[Docket No. FAA–2016–9418; Product Identifier 2016–NE–23–AD; Amendment 39–19167; AD 2018–02–14]

Airworthiness Directives; Honeywell International Inc. Turboprop and Turboshaft Engines

ACTION: Final rule.

**Figure 1 to Paragraph (h) of this AD. Combustion Chamber Case Assembly
Without the One-Piece Bleed Pad with P3 Boss**

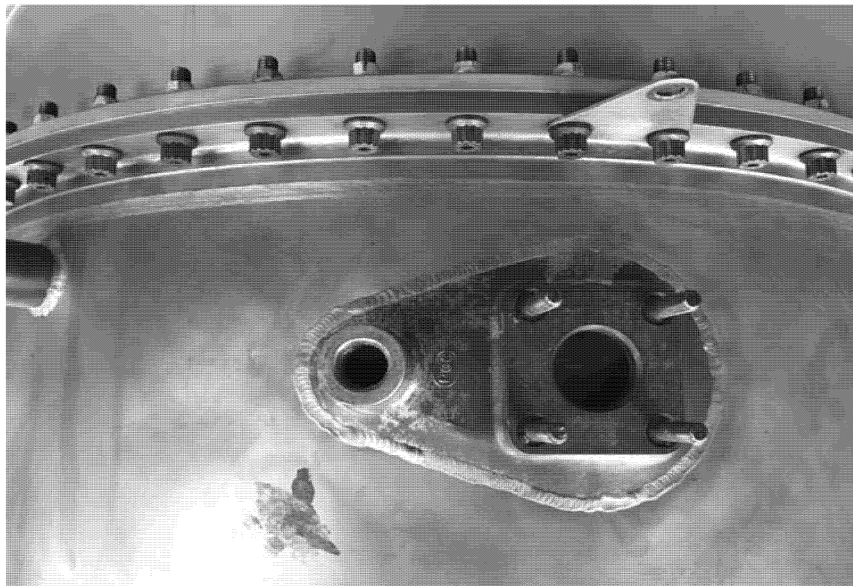
TPE331 model engines modified by STC SE383CH may be defined as the "Super 1" and "Super 2" for the compressor modification of the TPE331-1 and the TPE331-2, -2U, and -2UA engines, respectively. Figures 1 and 2 to paragraph (h) of this AD illustrate the appearance of combustion chamber case assembly, P/N

893973-5, without and with, respectively, the one-piece bleed pad with the P3 boss.

(2) For TPE331-3U, -3UW, -5, -5A, -5AB, -5B, -6, and -6A engines with combustion chamber case assemblies, P/Ns 869728-1, 869728-3, or 893973-5, installed, and without the one-piece bleed pad with P3 boss; and for TPE331-1, -2, and -2UA engines modified by National Flight Services, Inc., supplemental type certificate (STC) SE383CH, remove the combustion chamber case assembly from service at the next removal of the combustion chamber case from the engine, not to exceed 3,700 hours time-in-service since last hot section inspection.

Services, Inc., STC SE383CH, unless the combustion chamber case assembly has a one-piece bleed pad with P3 boss.
